ADDENDUM 04

Project: Vivion Rd Trail Segment 1
PROJECT NO: TAP 3454(401)

This addendum forms a part of the contract documents and modifies the original procurement documents dated October 2024.

IF A SEAL IS PRESENT ON THIS SHEET IT HAS BEEN ELECTRONICALLY SEALED AND DATED.

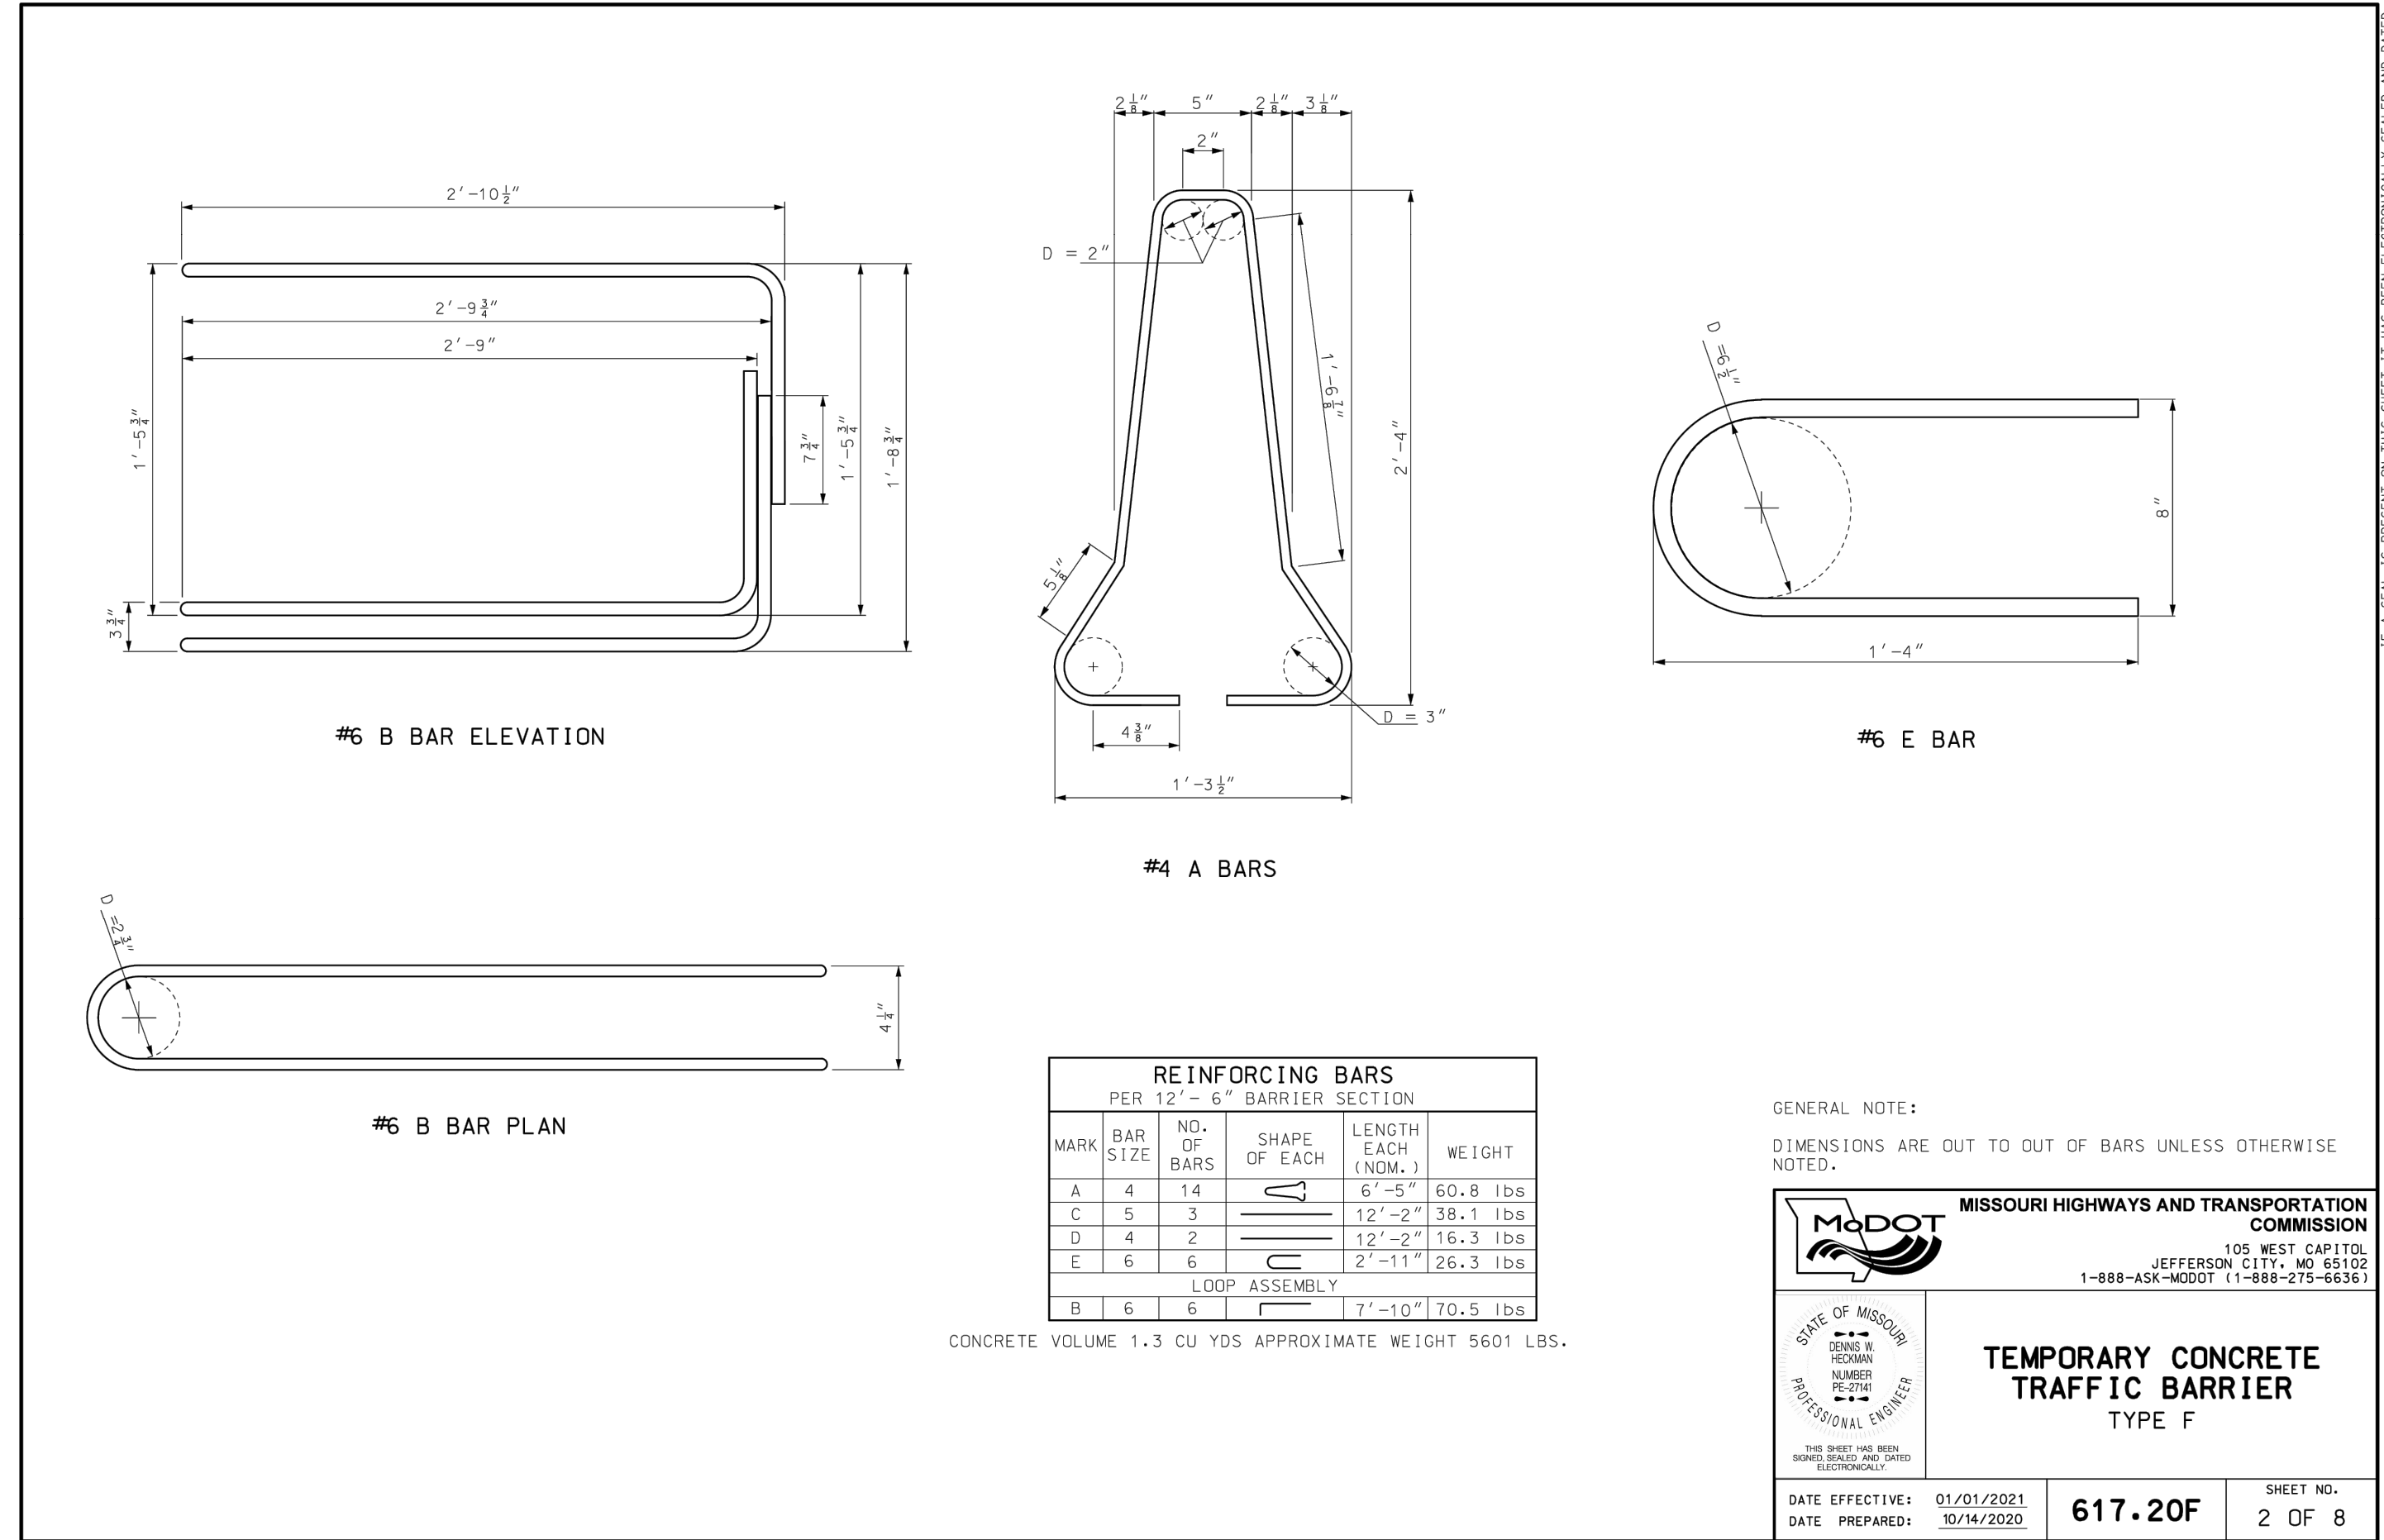
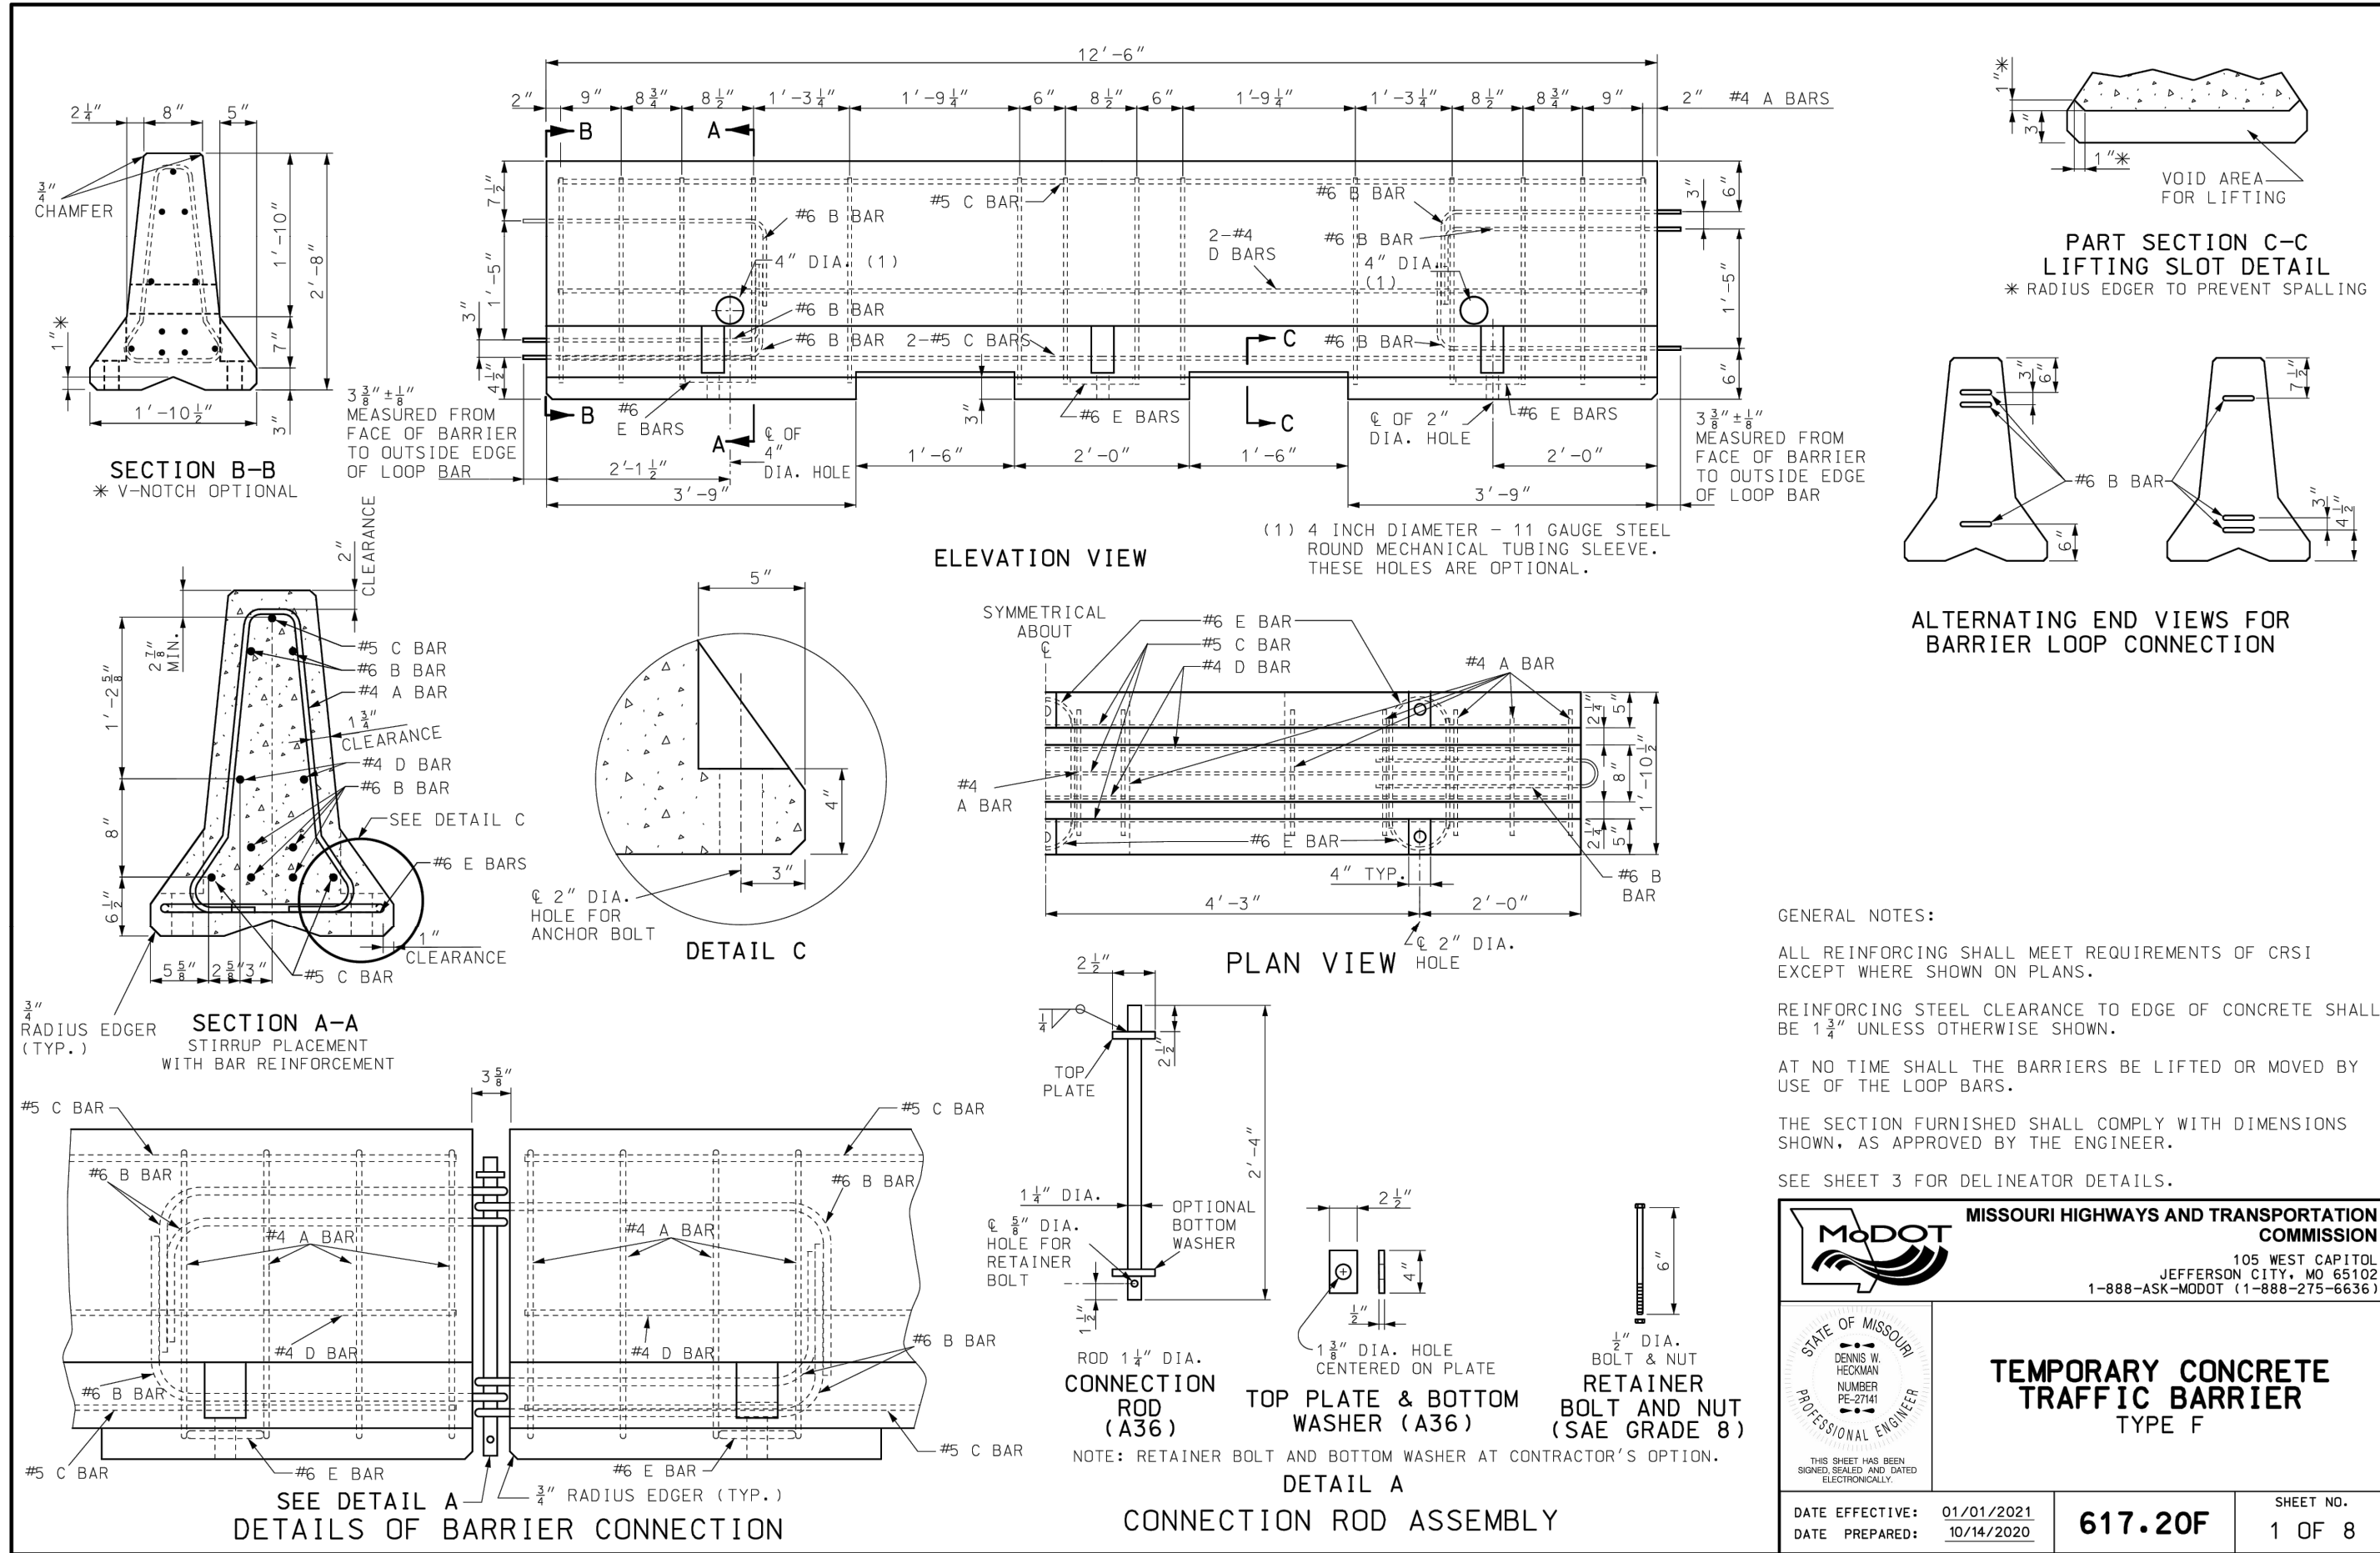
- 3. Will there be revisions coming, specifically there is a lot of confusion about Traffic Control?**

A Type F Barrier with a Tie-Down Strap is now called for in front of the guardrail and shown on sheet 26 of the plans. Appropriate details have also been added. Per discussions with MoDOT, the updates for the Type F Barriers with a Tie-Down Strap also include minimums for lane width adjacent to the barriers on the Temporary Traffic Control Plan (sheet 30 of the plans) to keep the lanes open.
